SCAPPOOSE PLANNING COMMISSION

Thursday, March 23rd, 2017 at 7:00 p.m.

5.1 DOCKET # SDR4-16/ PLA5-16

Lufkin Apartments LLC has requested approval of an application for Site Development Review (SDR4-16) and Property Line Adjustment (PLA5-16) for a proposed multi-family development consisting of three buildings; 1 building containing (4) studio units and the other two buildings each containing (8) two bedroom units (for a total of 20 units), and associated site amenities. The site is located at 33730 E. Columbia Ave., near the southwest corner of the E. Columbia Ave and NE West Lane Rd. intersection on property described as Columbia County Assessor Map # 3212-DB-00100 and 3212-DB-02900.

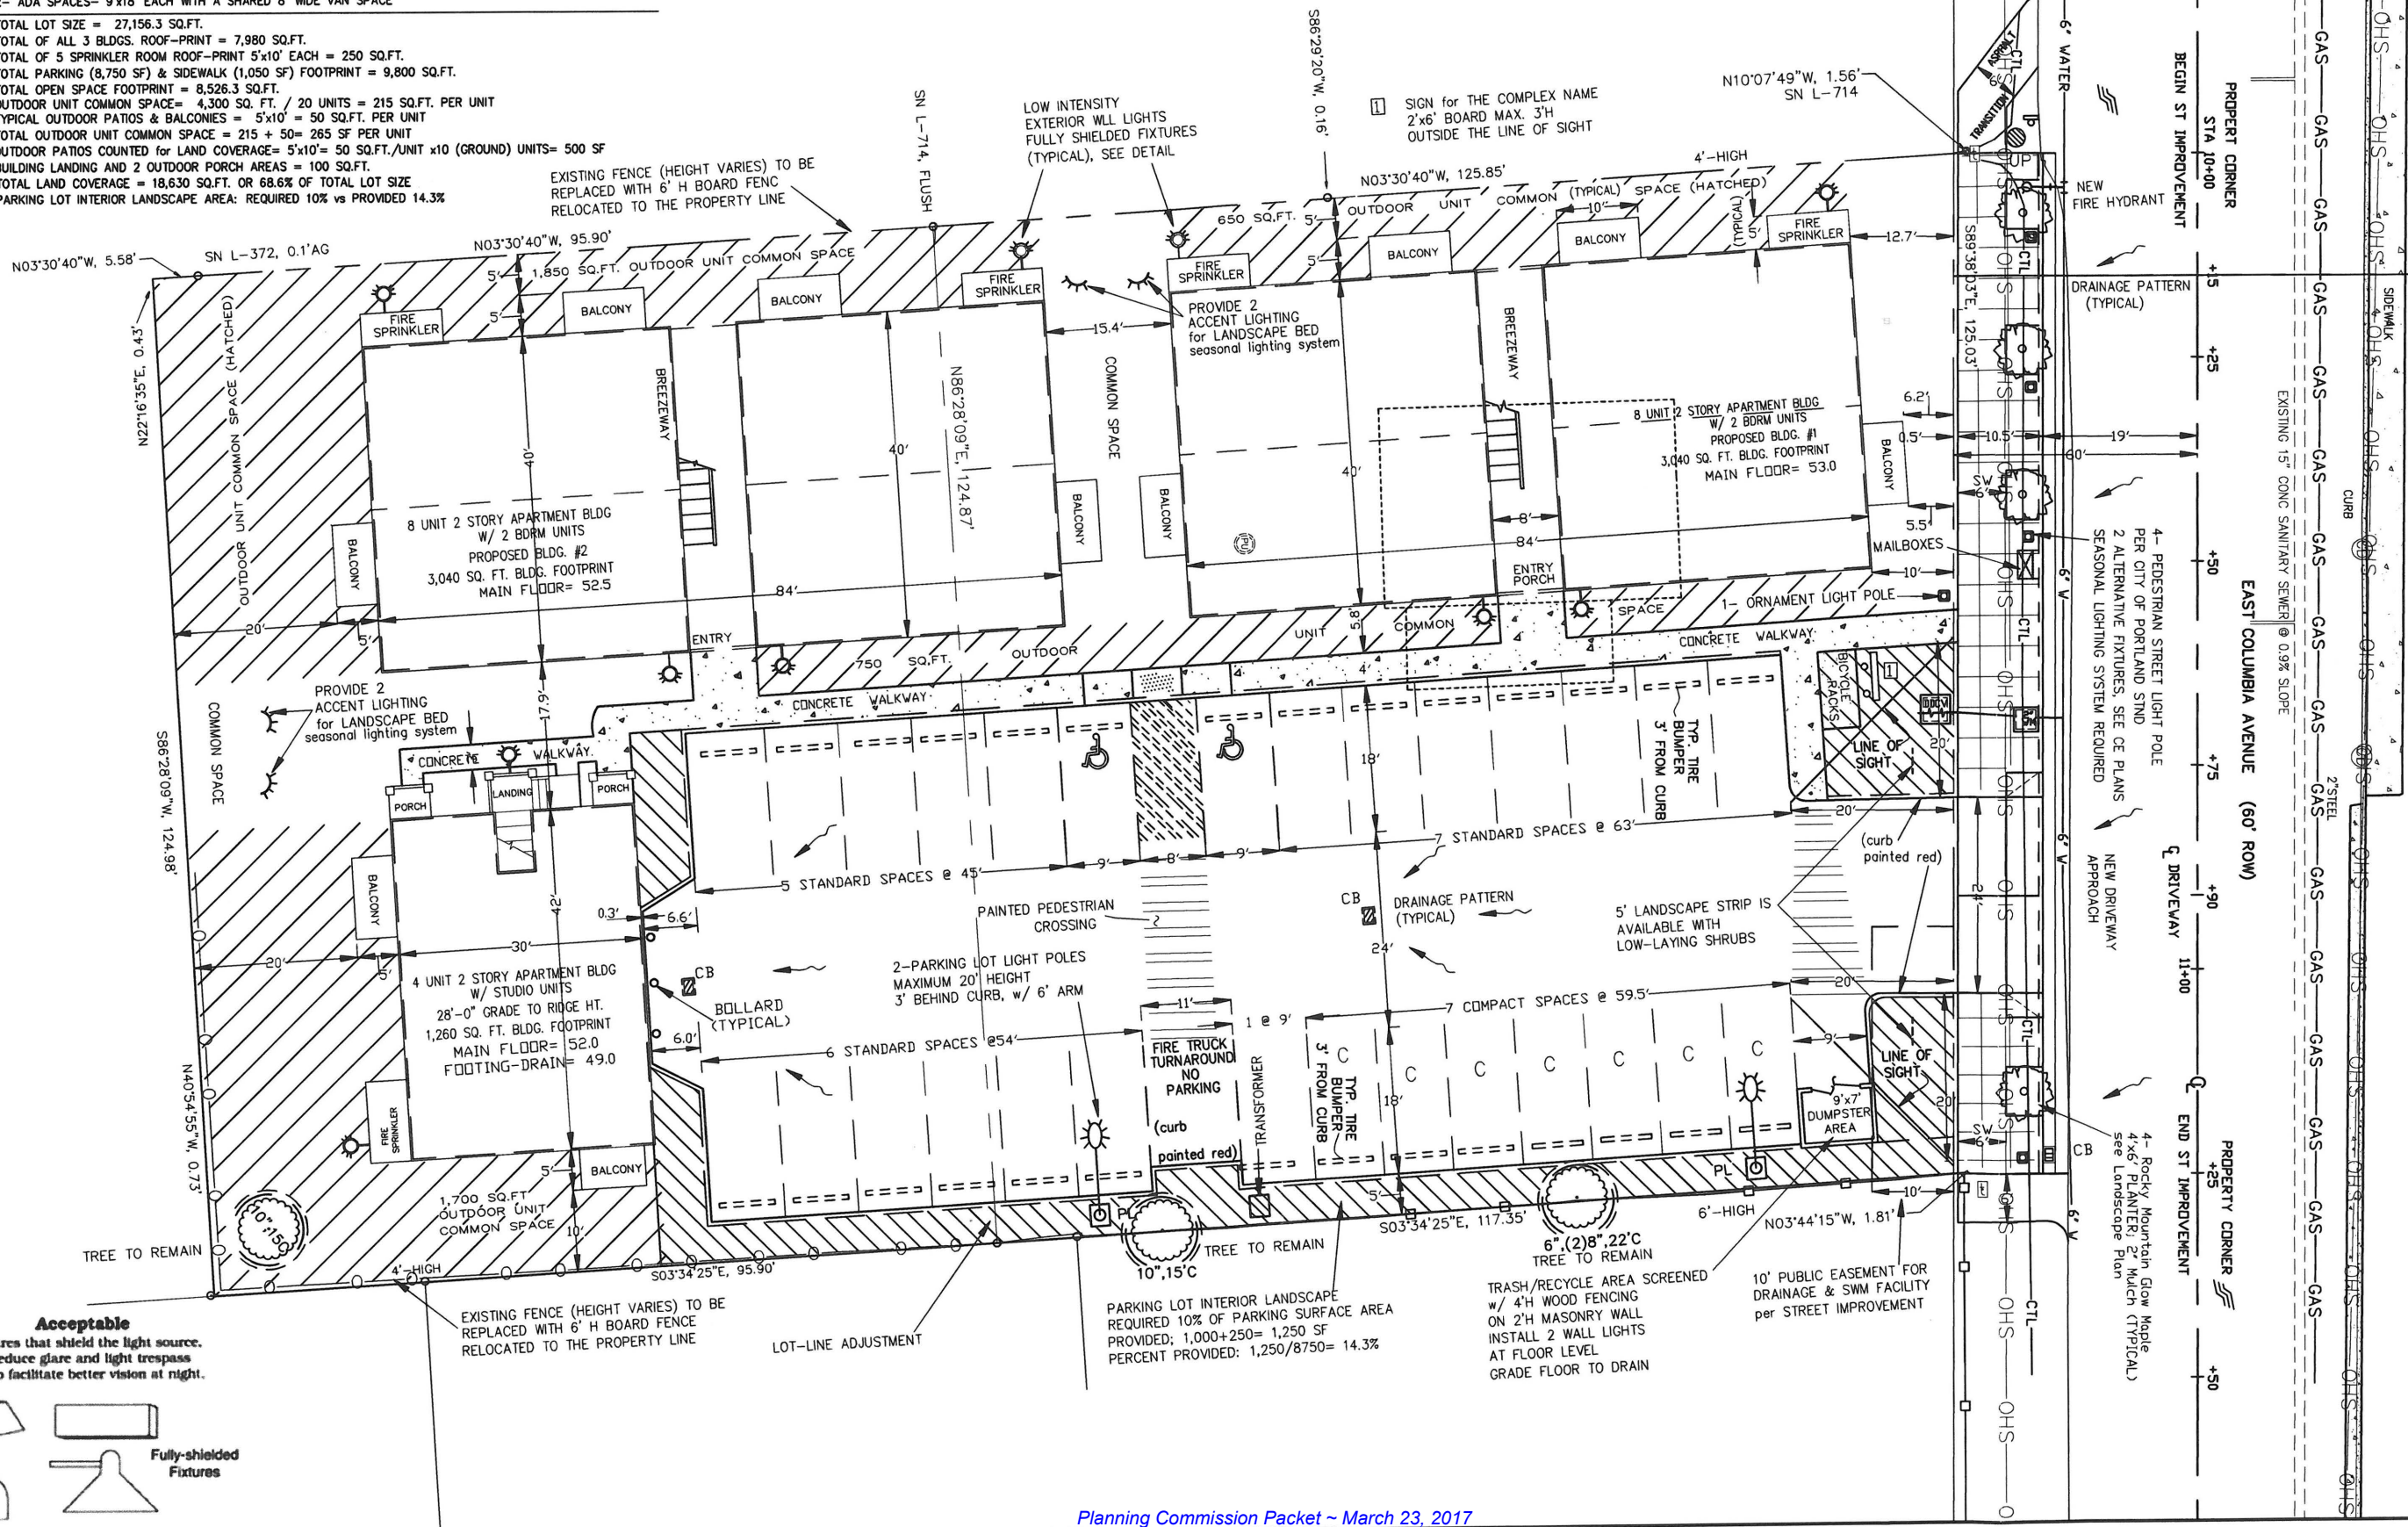
Finding: The applicant proposes lighting to provide adequate illumination per the Downtown Overlay standards. The site plan (**Exhibit 3**) shows the location of four proposed pedestrian scale street lights standing at 14-feet tall. The narrative (**Exhibit 2**) says that the parking lot will be illuminated by two 20-foot light poles, and that the

Finding: The site plan indicates a 9' by 7' enclosure is planned for the trash area, 10 feet from the street frontage. The applicant proposes to fully screen the garbage and recycling area with four foot high wood fencing set on a two foot high masonry wall. The site plan shows the transformer on the eastern edge of the property and the Conditions of Approval will require the transformer to be shielded from public view (**Exhibit 3**). Section 17.80.070 is satisfied.

Finding: The applicant has proposed (4) studio units and (16) two bedroom units which would require 28 parking spaces. The site plans and narrative (**Exhibits 2 & 3**) indicate that 19 standard parking spaces, 7 compact spaces, and 2 ADA spaces totaling 28 spaces will be provided. Section 17.106.030 is satisfied.

Finding: The proposed parking lot design (**Exhibit 3**) complies with the dimensional requirements for parking spaces and drive aisles as noted above. The standard parking spaces are 9'x18' and all the drive aisles provide the minimum 24-foot width for two-way traffic. The site plans demonstrate that no backing movements would occur on public streets. The applicant has illustrated wheel stops for the parking spaces that abut the sidewalk or landscaping. The proposed parking lot grading would need to direct stormwater away from the E. Columbia Avenue public sidewalk. Section 17.106.050 is satisfied.

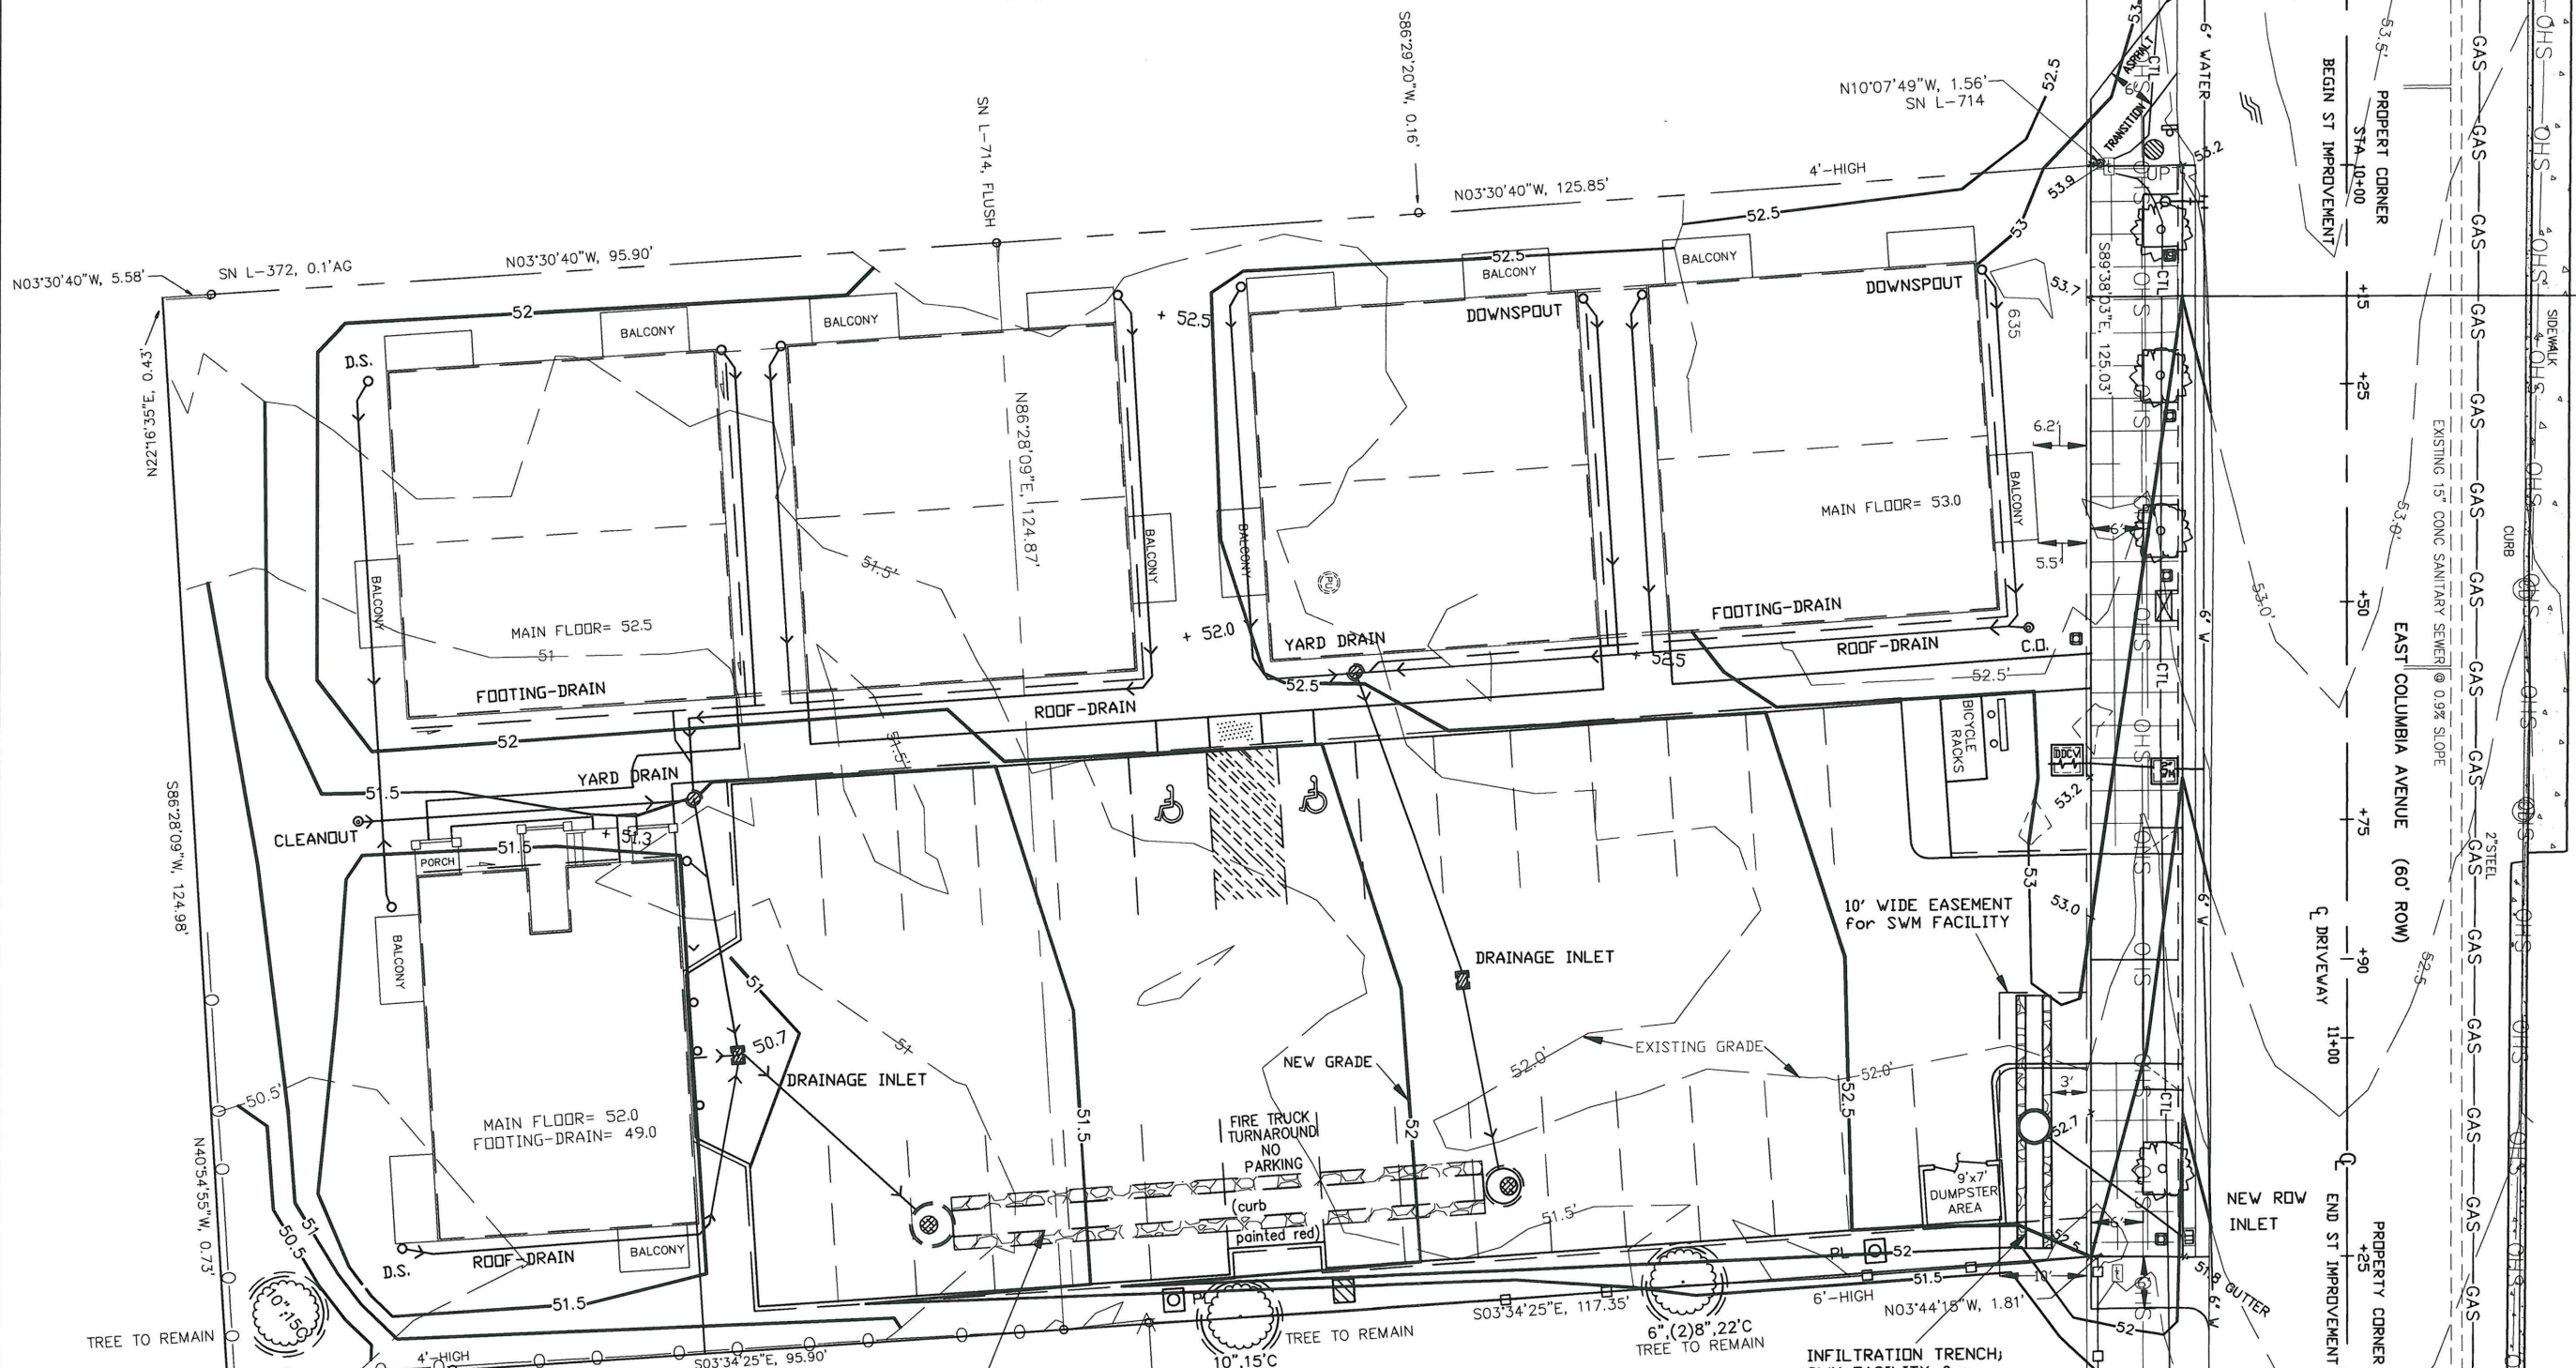
Finding: The site utility plans and narrative (**Exhibits 2 & 6**) propose collection of storm water runoff into two separate systems. One is located on-site for surface runoff from the onsite impervious areas which is conveyed into two inlets located within the parking lot in a manner to intercept surface water before it starts to accumulate. The other is located adjacent to the right-of-way (within a proposed public easement) to collect runoff from half street improvements. As previously stated, the City does not allow the addition of

any new drywells, therefore the applicant will need to redesign the proposed system to provide for surface infiltration (retention) basin. The Conditions of Approval require submittal of a final storm report prepared by a professional engineer for the review and approval of the City Engineer. Section 17.154.100 is satisfied.
